CITY OF ALBUQUERQUE

Re: 900 Griegos Road Townhomes - Grading and Drainage Plan
Request for Permanent C.O. – **Accepted**
Engineer's Stamp dated: 03-06-2013
Certification dated: 11-05-2013

Re: 900 Griegos Road Townhomes Grading and Drainage Plan
Engineer's Stamp date 03-06-13 (F-14/D067)

**RE: Grading and Drainage Plan
900 Griegos (f14/D067)**

DRAWN BY J. G. ROSSITER	900 GRIEGOS ROAD TOWNHOUSE PROJECT	DATE 11-18-12	SHEET # 1	JOB # 211208
GRADING AND DRAINAGE PLAN		R. G. ROSSITER ENGINEERING 1000 N. 1ST ST., SUITE 100 SAN JOSE, CA 95131 TEL: 408-281-1111		
DRAWN SCALE P.L. 1/4"=1'-0"		JOB # 211208

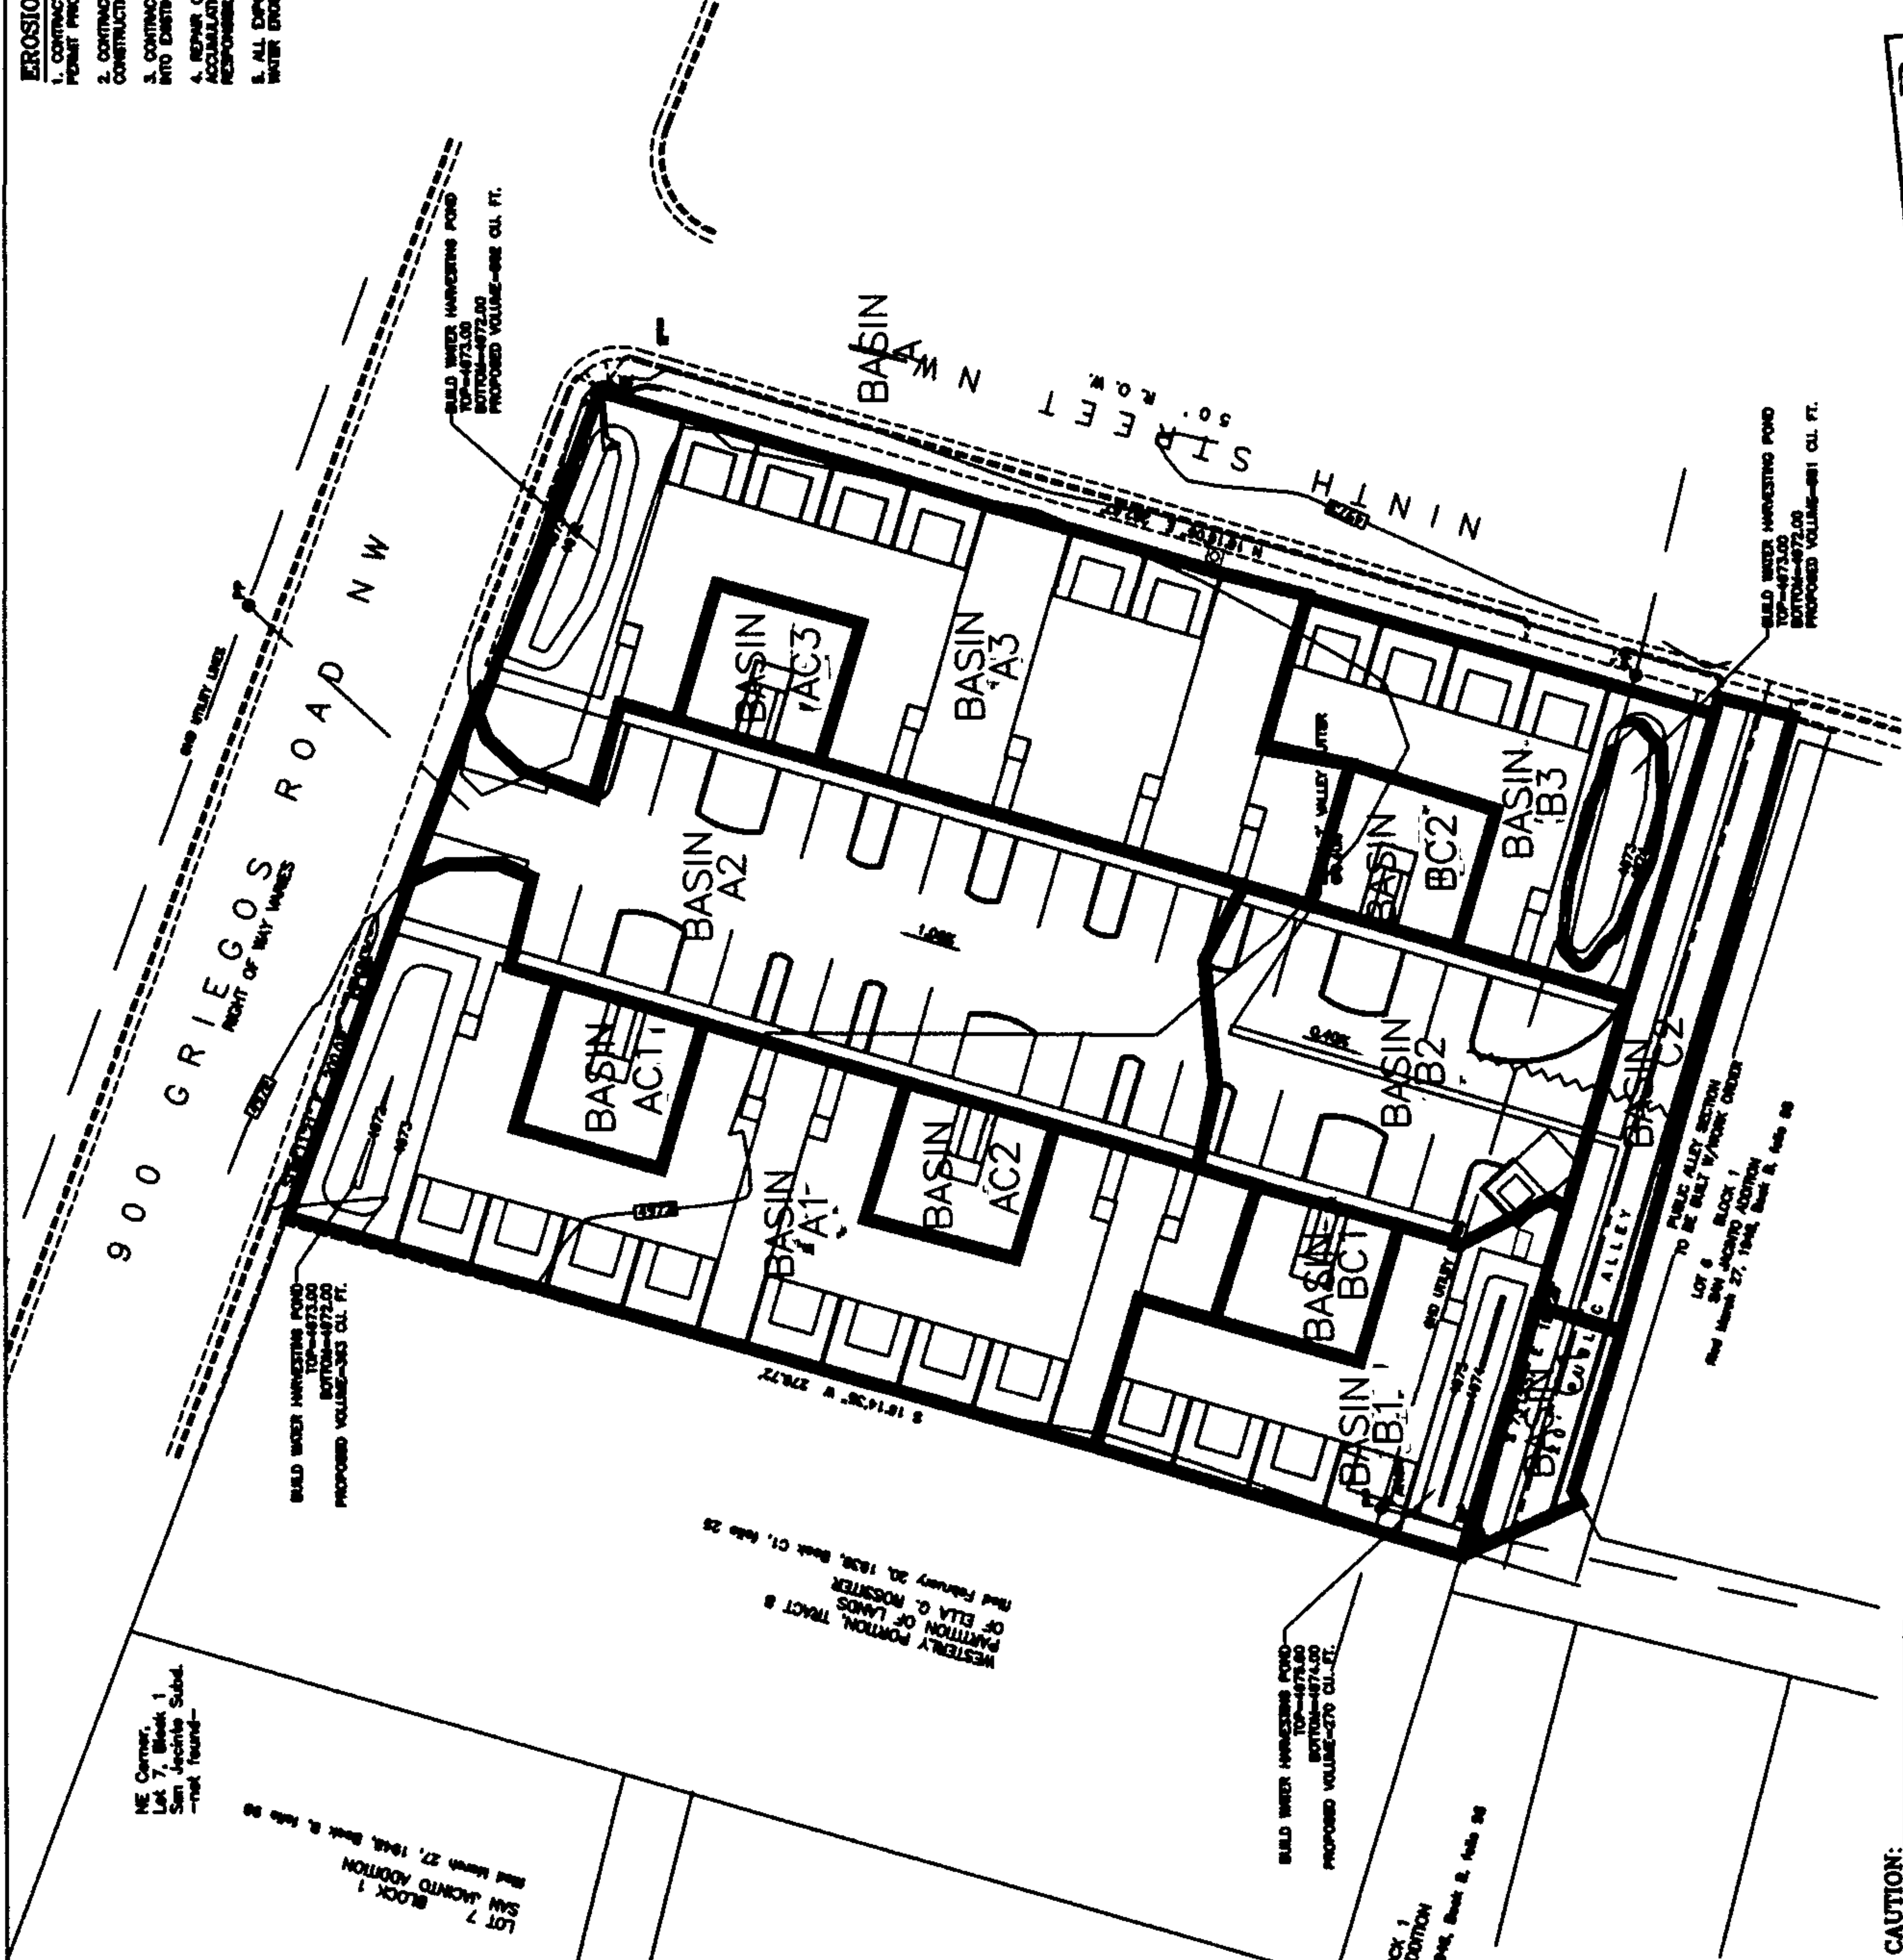
Based upon the information provided in your submittal received 11-26-12, the above referenced plan cannot be approved for Building Permit until the following comments are addressed:

- Please show direction of roof drainage and any wall openings that will be utilized to pass flow through the property.
- Indicate on the plan the outfalls for each sub-basin and simplify if possible.
- Show the overflows for each of the proposed ponds.
- The public alleyway should be graded to drain the entire alley to 9th Street.
- New development will be limited to a discharge of 2.75 cfs/acre.
- Additional spot elevations for the property to the west of the site need to be provided. Quantify any offsite flows being received from this area.
- Top-of-curb elevations need to be provided along 9th Street.
- Include a legible FIRM map on the plan set as well as a benchmark designation.
- What is being represented along the northwest property line? What is being depicted by the symbol on the eastern edge of the northeastern pond?

The purpose of this letter is to accompany the enclosed grading plan for the referenced project. This plan has been modified to address your comments dated December 5, 2012. The following is a summary of your comments with the annotation as to how the plans were modified to address the comments.

1. Please show roof drainage direction and wall openings used to pass flow

We have added typical roof drainage patterns, they are the same for all roofs and consistent with the basin maps. A note has been added to clarify the turned blocks in the internal walls for drainage

2. Indicate outfalls for each basins

Due to reduced allowed discharge, bonds AC1-3 and BC1-2 will retain. All basins with an A letter discharge to Griegos and the B nomenclature discharge to 9th. The C's are all alley.

3. Show the overflows for each pond

We have better identified the overflows for all the ponds. The AC/BC – courtyard ponds will fill and spillover curb, to asphalt so not defined overflow

4. Public alley way should be graded to 9th.

We have moved the high point as far west as possible. The surrounding property is graded and there is current access from alley to the property to the west. We are unable to get the entire alley to drain east. We are not paving the portion of ally that is drains west, therefore we are reducing the current flow draining west.

5. New Development limited to 2.5 cfs/ ac

We have reduced site discharge in the 100-year, 6-hour event to 3.48 cfs which is 2.65 cfs per acre. We have accomplished by creating harvest ponds for small basins, these can spill and are shallow so the 100-year 6-hour volume was utilized.

6. Additional spot elevations need to be added. And offsite flows quantified

We have added spots, there are no offsite flows affecting the site. There curbs on north and east, and solid wall on west, the alley to south drains west.

7. Add top of curbs on 9th

We have added these

8. Included legible firm and benchmark.

The firm was downloaded directly from FEMA, the cross hatching for zone x-protected by levee is causing the issue. We changed scale to make more legible. The benchmark was added

9. What is being represented along nw property lines

The drawing was cleaned up to eliminate unknown or undefined lines-

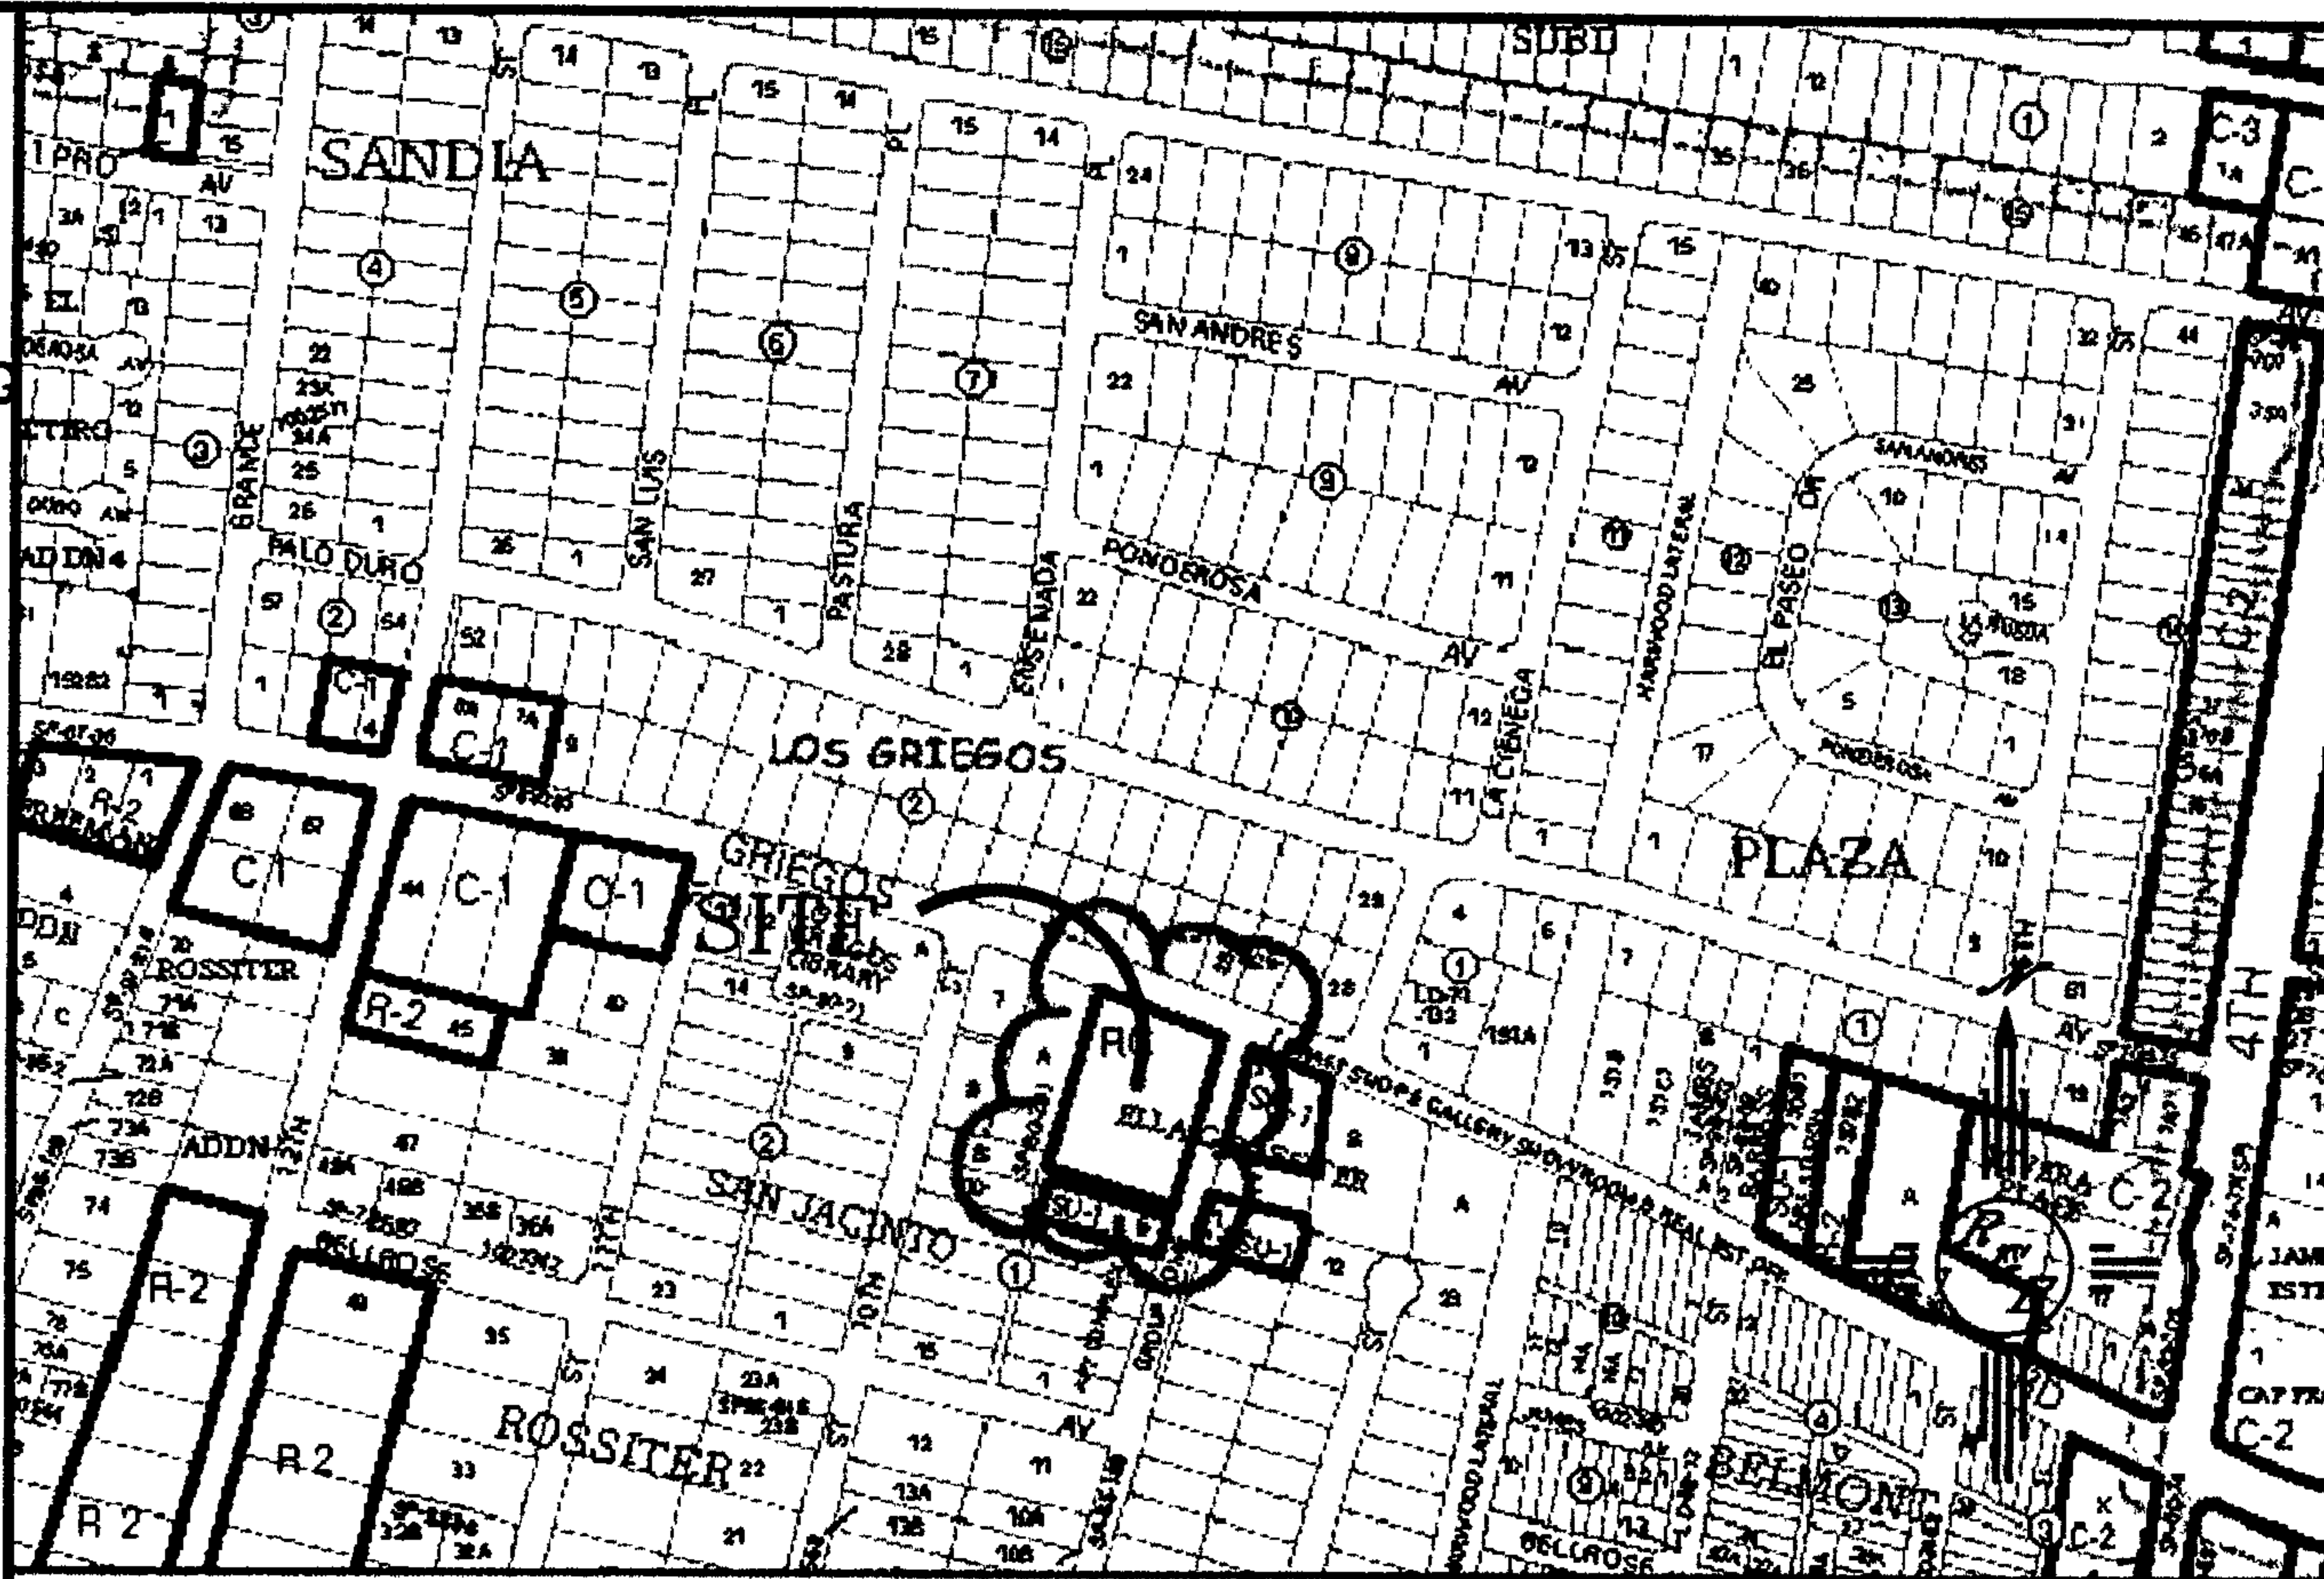
Simplify to 1/
Sub basins &
Resubmit
